SILVERADO RANCH FILING NO. 2

Grading & Erosion Control Plans

El Paso County, Colorado

V1_Grading & Erosion Control Plan.pdf Markup Summary

OVERALL SITE PLAN

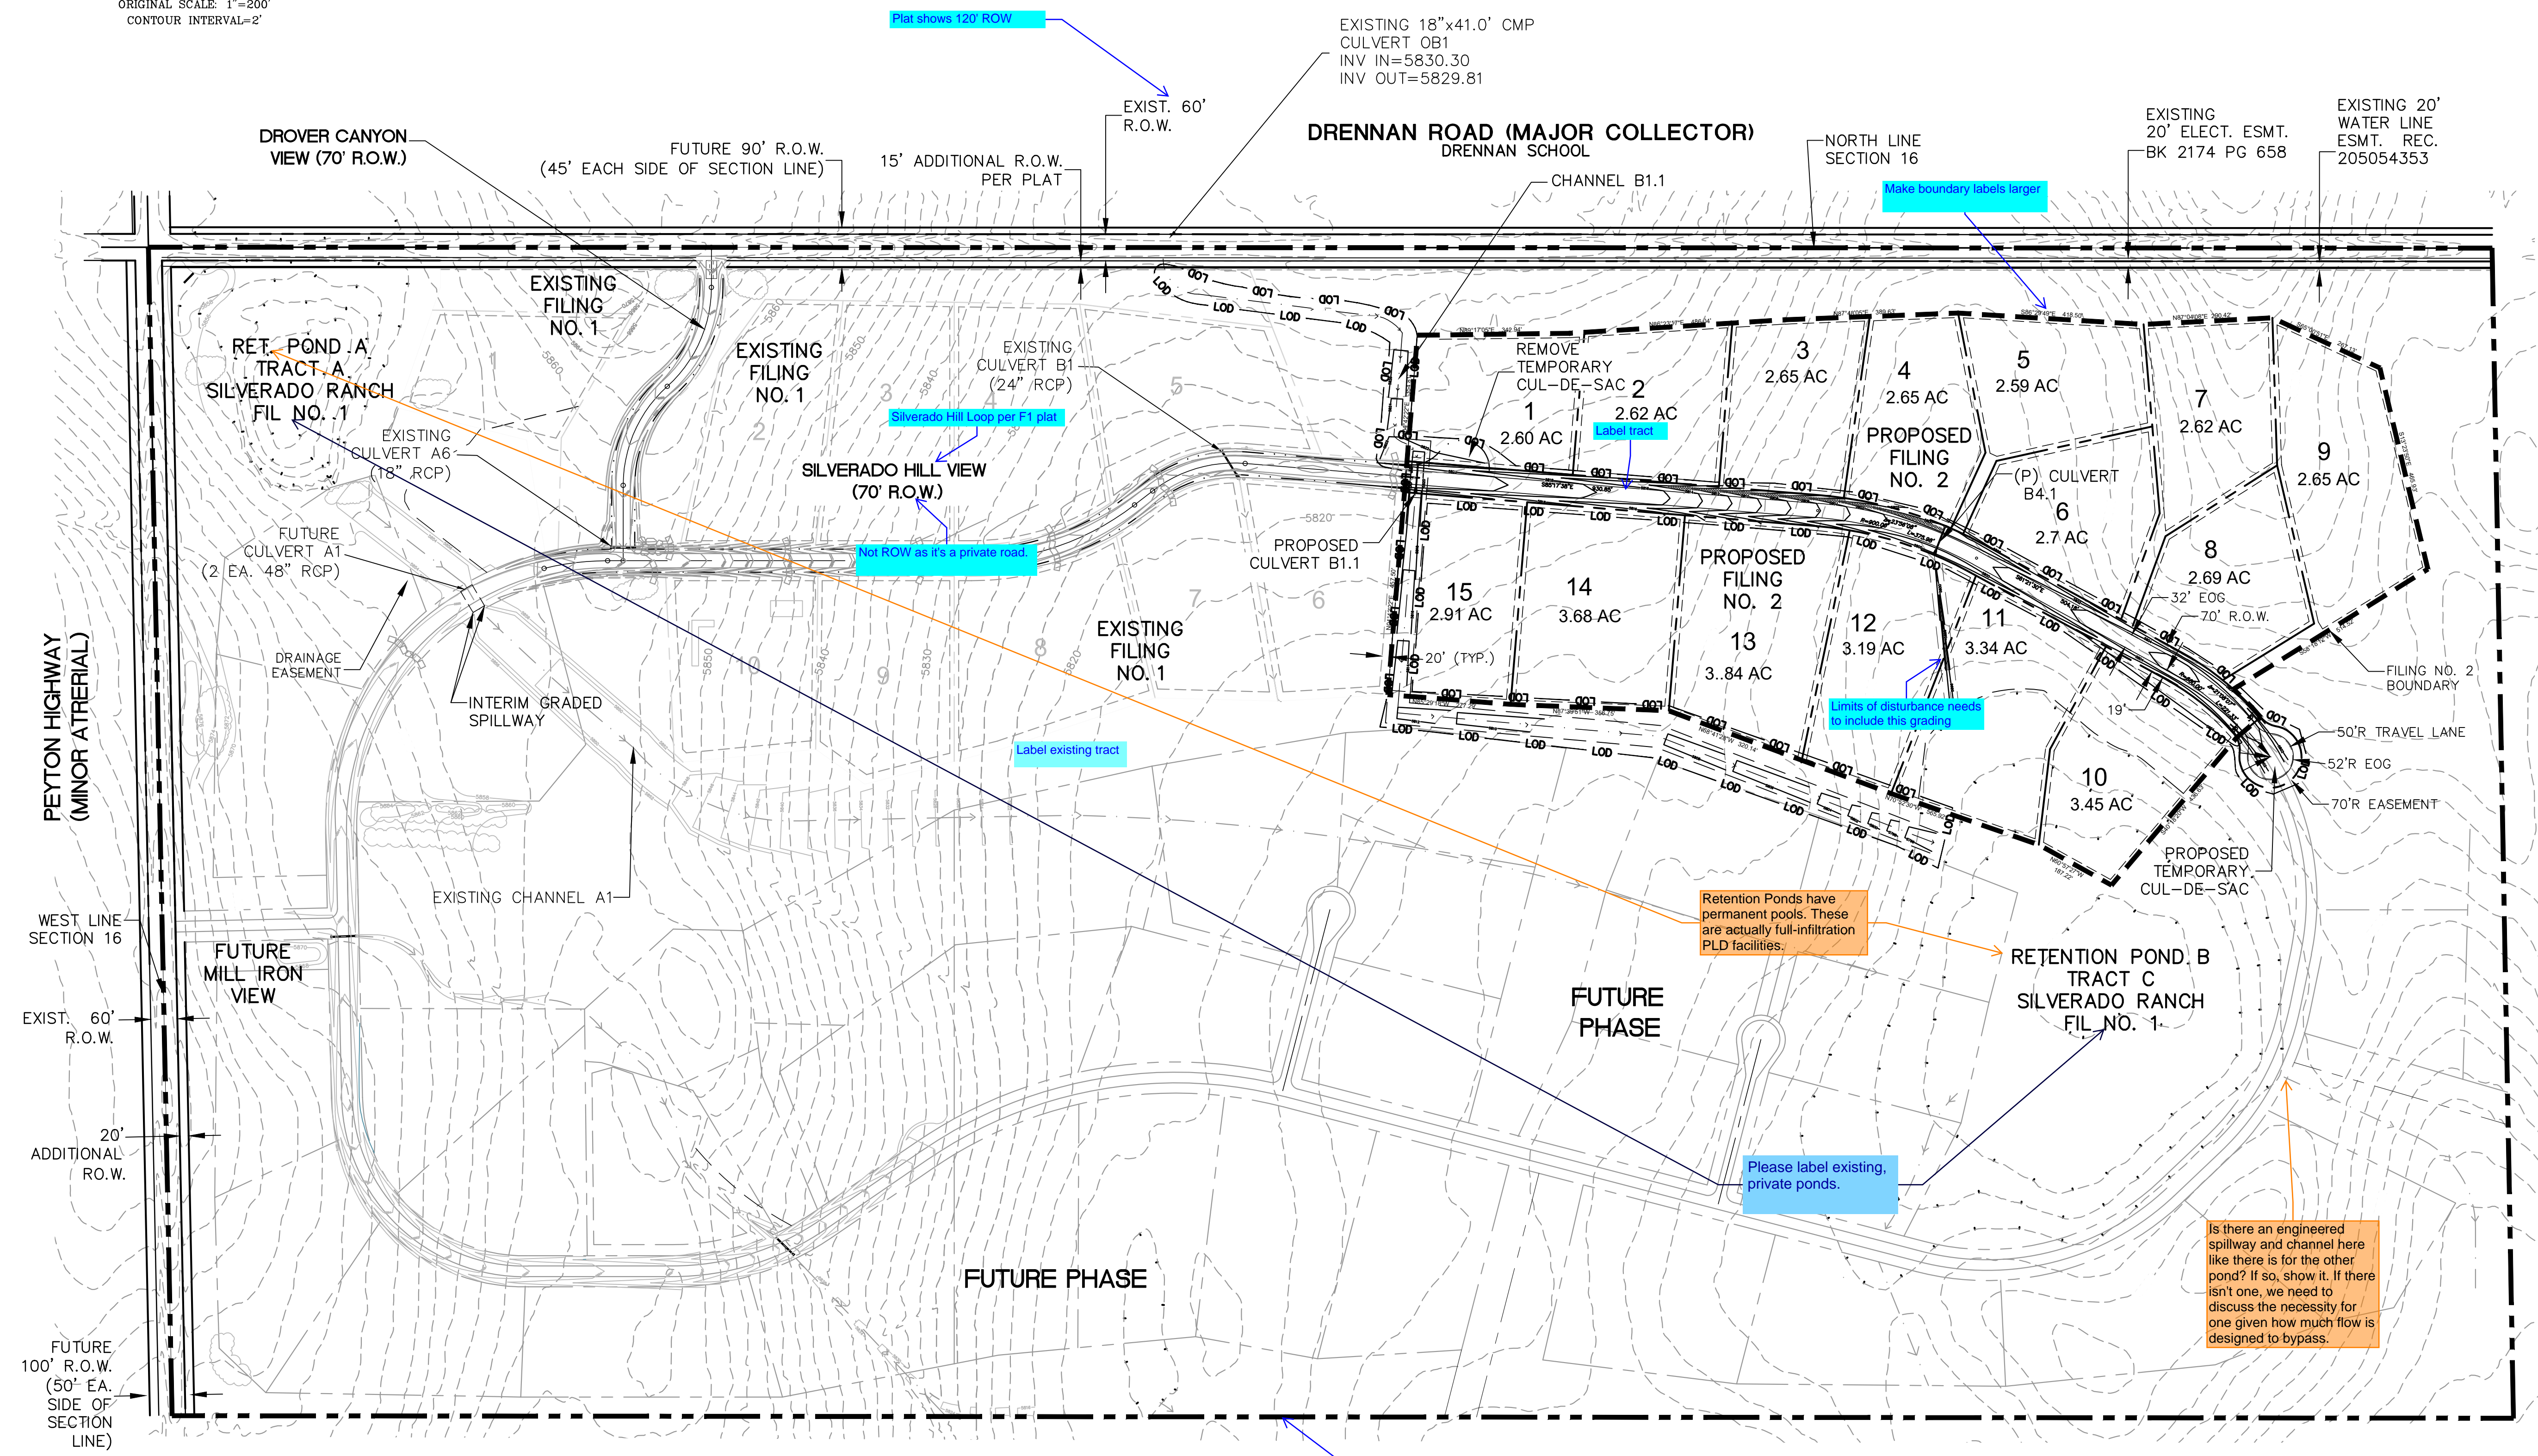
Add drainage flow arrows onsite and offsite.

Plat shows 120' ROW

Not ROW as it's a private road.

Retention Ponds have
permanent pools. These
are actually full-infiltration
PLD facilities.

Please label existing,
private ponds.

Limits of disturbance needs
to include this grading

Label existing tract

Make boundary labels larger

Is there an engineered
spillway and channel here
like there is for the other
pond? If so, show it. If there
isn't one, we need to
discuss the necessity for
one given how much flow is
designed to bypass.

Label overall Silverado Boundary

Please label existing, private ponds.

Plat shows 120' ROW

Limits of disturbance needs to include this grading

Label overall Silverado Boundary

Make boundary labels larger

Silverado Hill Loop per F1 plat

Not ROW as it's a private road.

Retention Ponds have permanent pools. These are actually full-infiltration PLD facilities.

Is there an engineered spillway and channel here like there is for the other pond? If so, show it. If there isn't one, we need to discuss the necessity for one given how much flow is designed to bypass.

Label existing tract

GRADING AND EROSION CONTROL PLAN

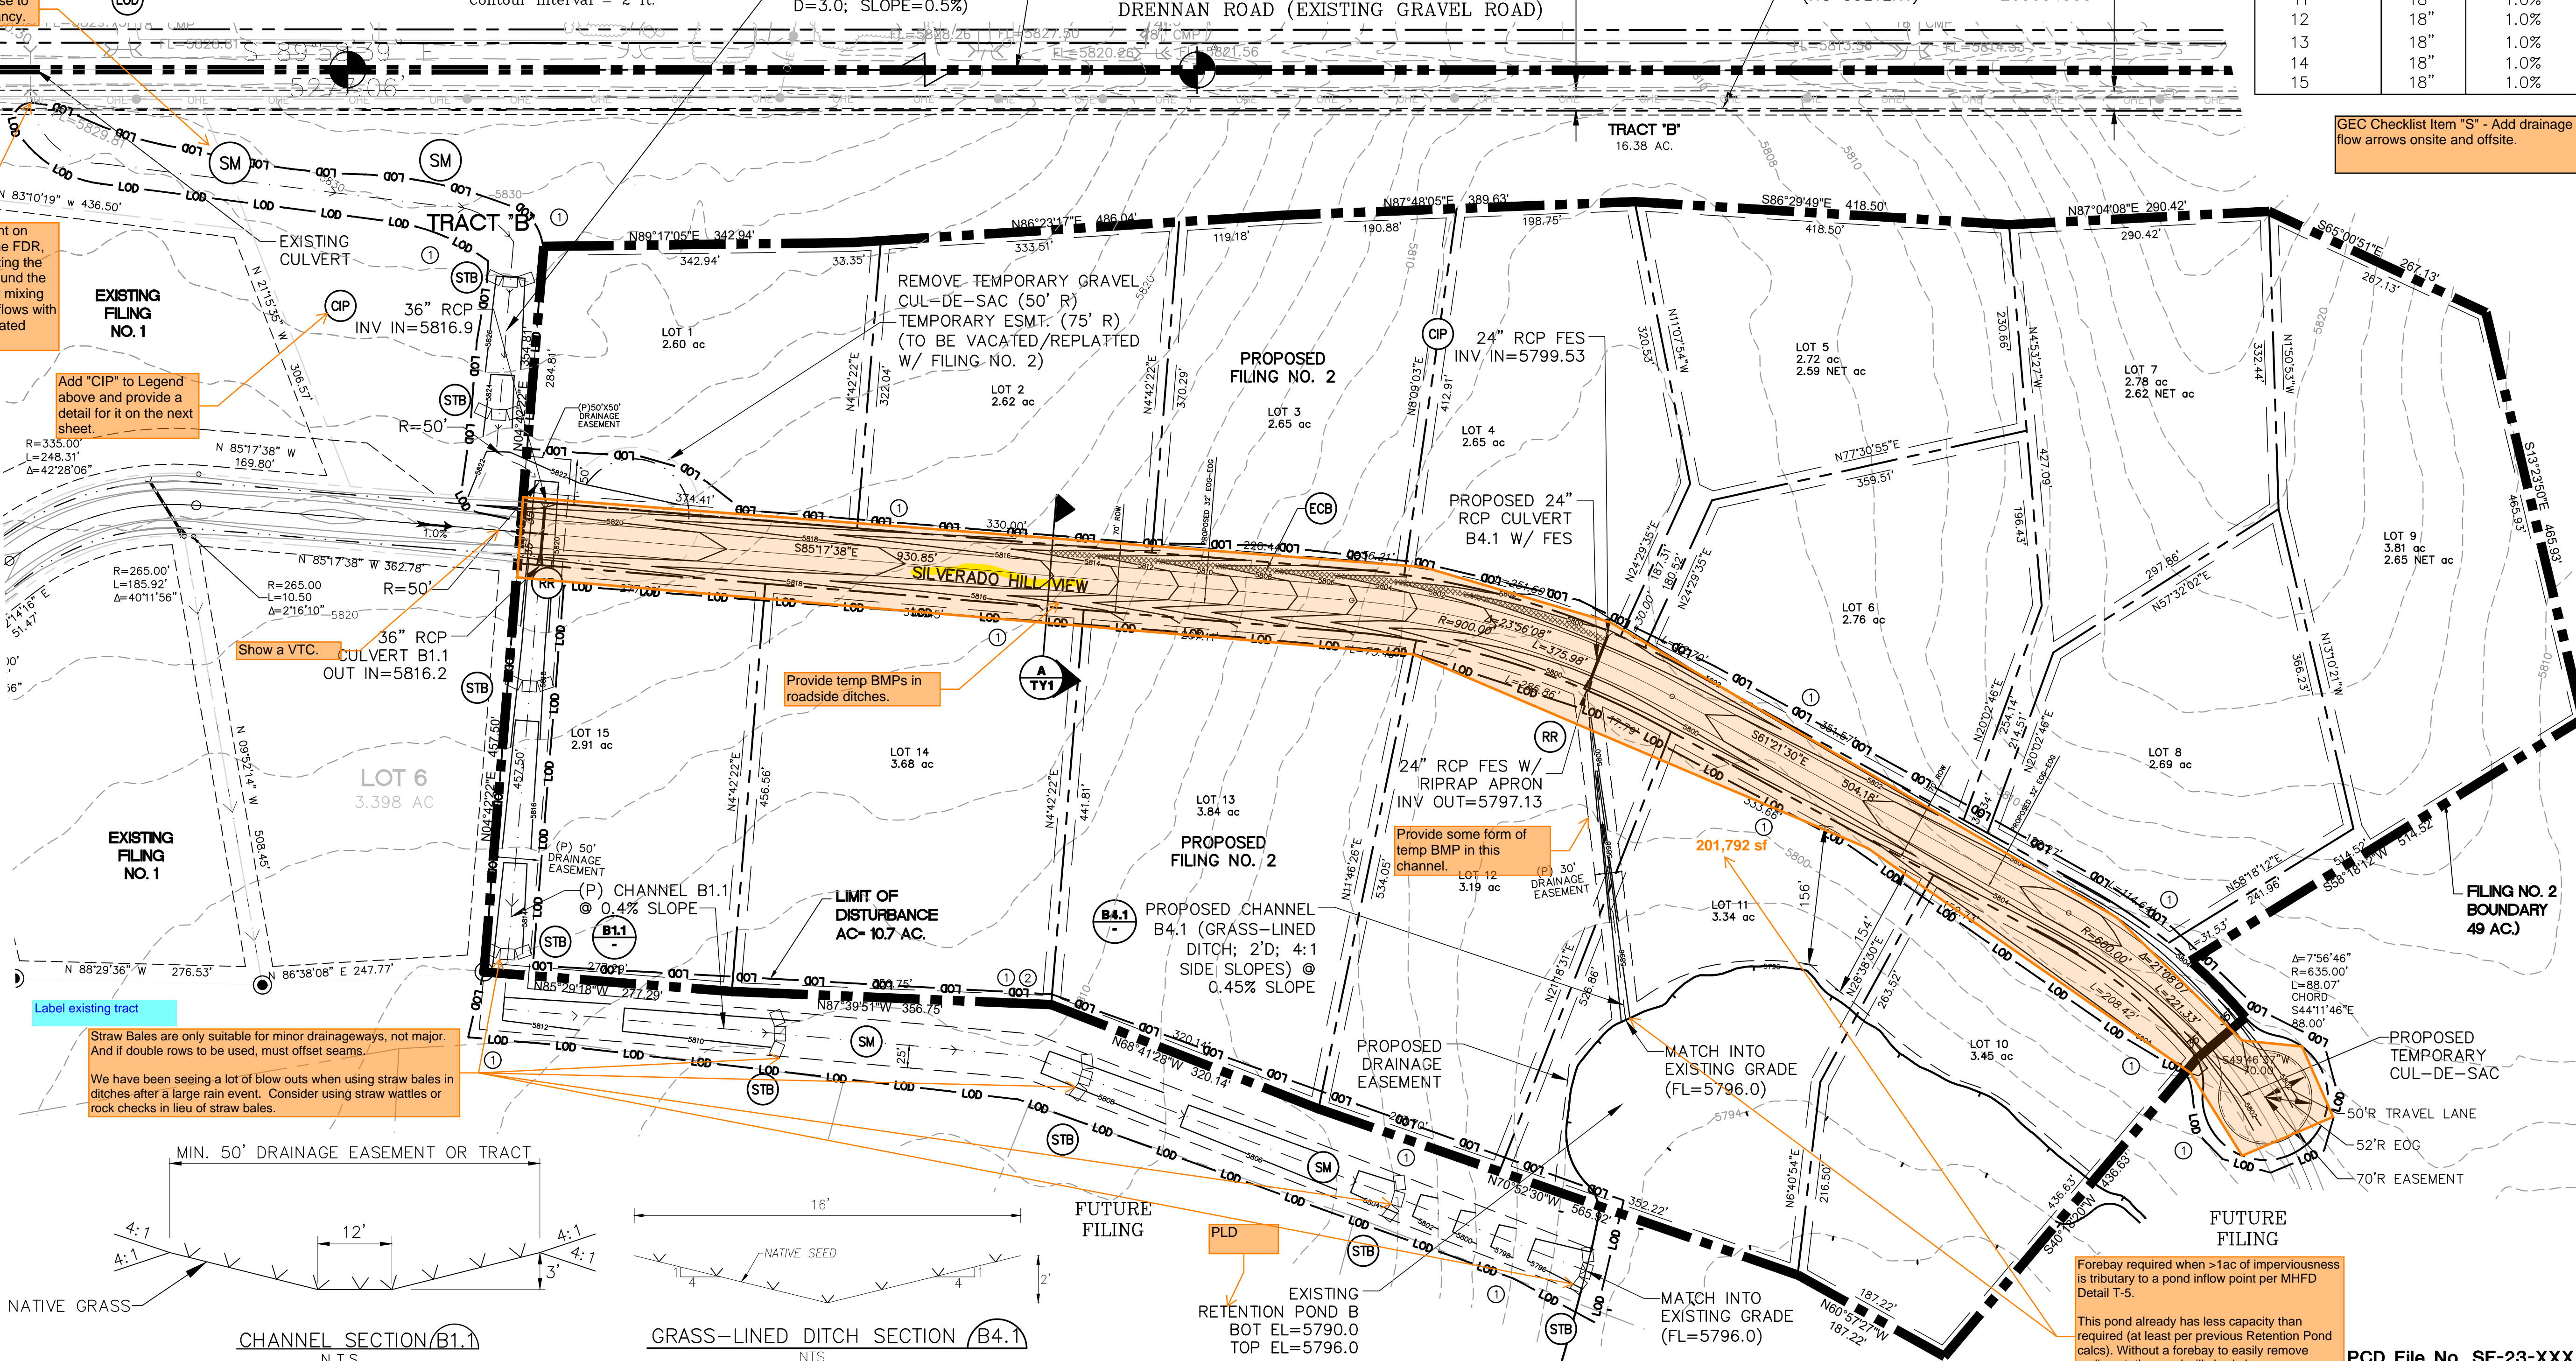
Checklist Item V. Label all proposed temporary construction BMPs by phase of implementation (initial, interim, final).

Did you intend to show SF somewhere on the GEC Plan? I don't see any.

GEC Checklist Items H and M. If "limits of disturbance" and "construction boundary" are the same, change to "limits of construction/disturbance" or otherwise show as separate line types for each on the legend and figure.

GEC Checklist Item "P" - identify areas of cut and fill.

Add a general note: all areas to be vegetated with seeding should also be temporarily stabilized via surface roughening or some other means.

GEC Checklist Item "S" - Add drainage flow arrows onsite and offsite.

SM or TM? Revise to remove discrepancy.

Per my comment on PDF pg 13 of the FDR, consider re-routing the offsite flows around the pond to prevent mixing of clean offsite flows with needs-to-be-treated roadway runoff.

Add "CIP" to Legend above and provide a detail for it on the next sheet.

Show a VTC.

Provide temp BMPs in roadside ditches.

Provide some form of temp BMP in this channel.

Straw Bales are only suitable for minor drainageways, not major. And if double rows to be used, must offset seams. We have been seeing a lot of blow outs when using straw bales in ditches after a large rain event. Consider using straw wattles or rock checks in lieu of straw bales.

Forebay required when > 1ac of imperviousness is tributary to a pond in flow point per MHFD Detail T-5. This pond already has less capacity than required (at least per previous Retention Pond calcs). Without a forebay to easily remove sediment, the pond will slowly lose even more capacity over time. We can revisit this discussion once PLD calcs are provided in FDR.

GEC Checklist Item "S" - Add drainage flow arrows onsite and offsite.

Add a general note: all areas to be vegetated with seeding should also be temporarily stabilized via surface roughening or some other means.

Forebay required when >1ac of imperviousness is tributary to a pond inflow point per MHFD Detail T-5.

This pond already has less capacity than required (at least per previous Retention Pond calcs). Without a forebay to easily remove sediment, the pond will slowly lose even more capacity over time. We can revisit this discussion once PLD calcs are provided in FDR.

Straw Bales are only suitable for minor drainageways, not major. And if double rows to be used, must offset seams.

We have been seeing a lot of blow outs when using straw bales in ditches after a large rain event. Consider using straw wattles or rock checks in lieu of straw bales.

GEC Checklist Items H and M. If "limits of disturbance" and "construction boundary" are the same, change to "limits of construction/disturbance" or otherwise show as separate line types for each on the legend and figure.

SM or TM? Revise to remove discrepancy.

Add "CIP" to Legend above and provide a detail for it on the next sheet.

Show a VTC.

Provide some form of temp BMP in this channel.

Provide temp BMPs in roadside ditches.

Did you intend to show SF somewhere on the GEC Plan? I don't see any.

GEC Checklist Item "P" - identify areas of cut and fill.

GEC Checklist Item V. Label all proposed temporary construction BMPs by phase of implementation (initial, interim, final).

Per my comment on PDF pg 13 of the FDR, consider re-routing the offsite flows around the pond to prevent mixing of clean offsite flows with needs-to-be-treated roadway runoff.

Label existing tract
